Draft Regulation

Building Act
(R.S.Q., c. B-1.1)

Construction Code — Amendments

Regulation to amend the Construction Code*

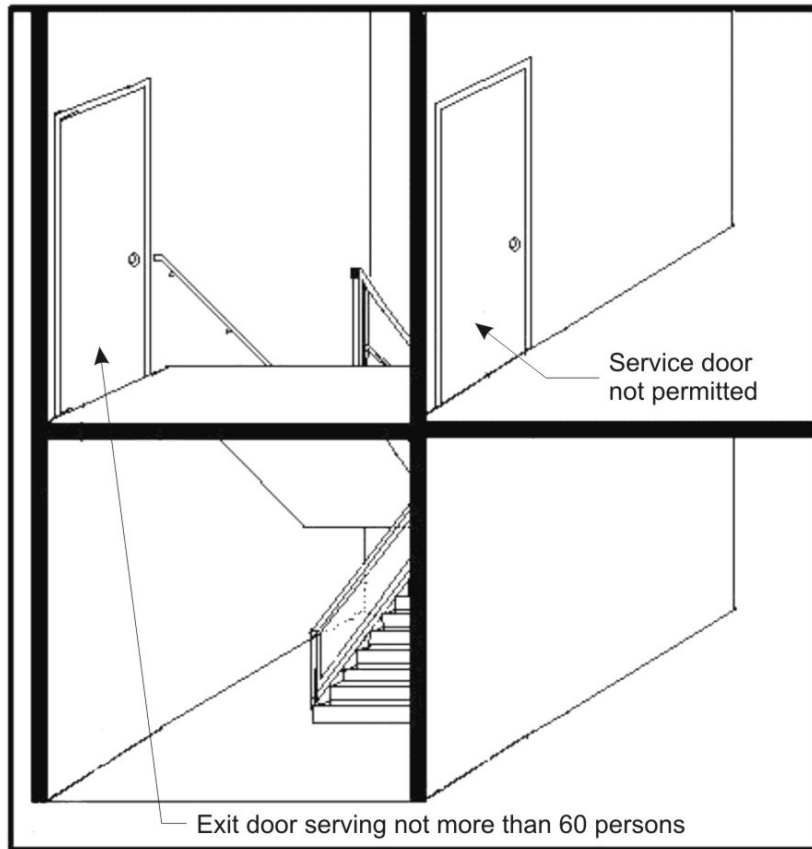
“(5) by adding the following after note A-3.4.1.6.(2):

“A-3.4.2.1.(2) Minimum Number of Exits. When the only exit is separated and leads to the outside at a level other than the level it serves, no other access door shall be installed at that exit at a storey other than the storey served. This requirement is necessary to reduce the risk of smoke filling the only exit serving the floor area or parts of floor areas having access to that only exit. (See Figure A-3.4.2.1.(2).);

Figure A-2.4.2.1.(7) and (8)
Suds Pressure Zones Connections.”;

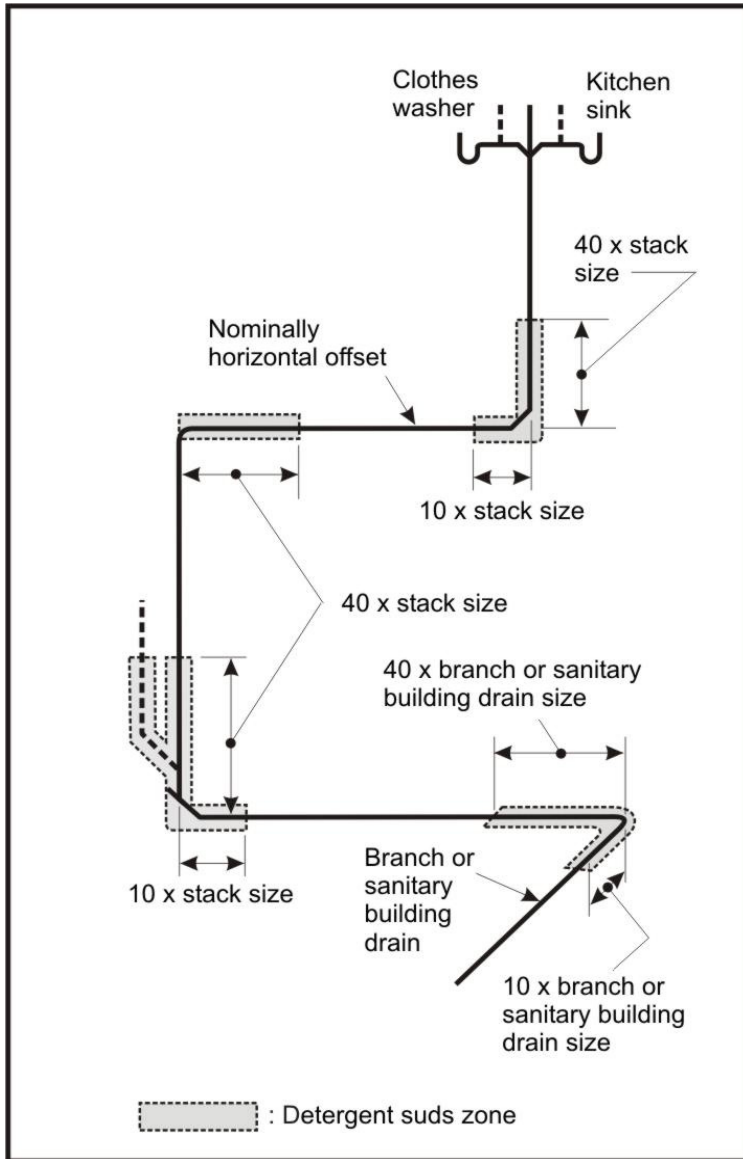
(6) by replacing note A-2.4.2.1.(7) in paragraph 39 by the following:

“A-2.4.2.1.(7) and (8) Suds Pressure Zones Connections

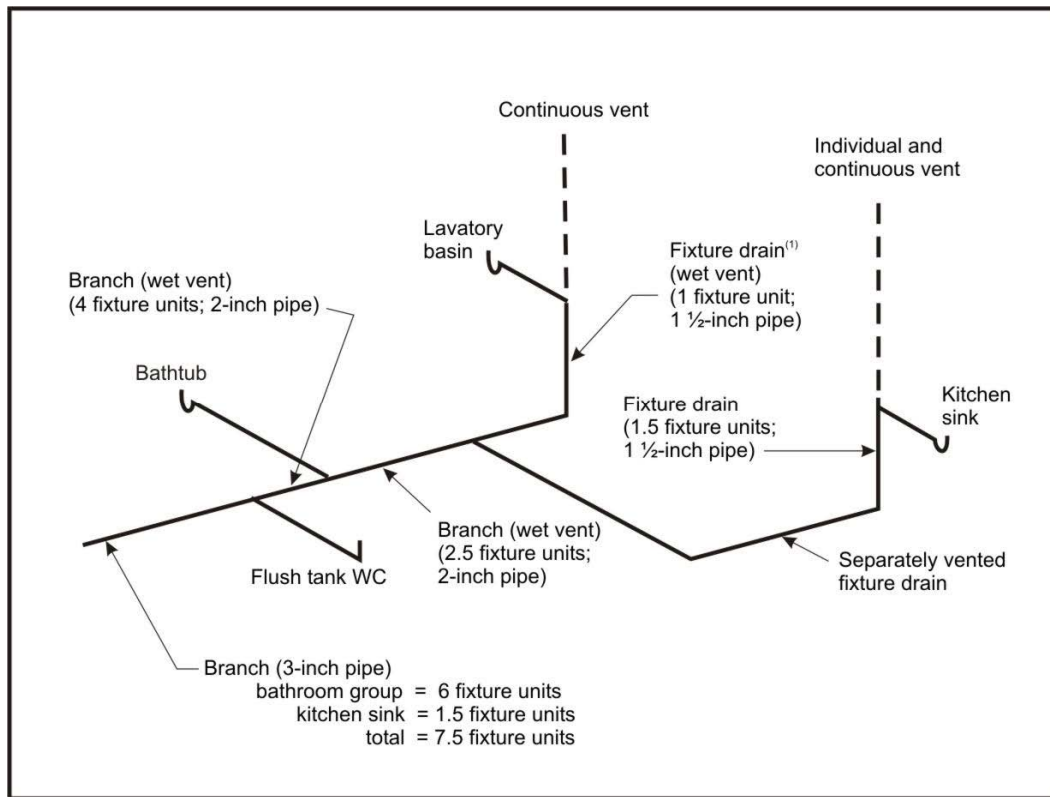
(7) by replacing Figure A-2.5.2.1. in subparagraph b of paragraph 46 by the following:
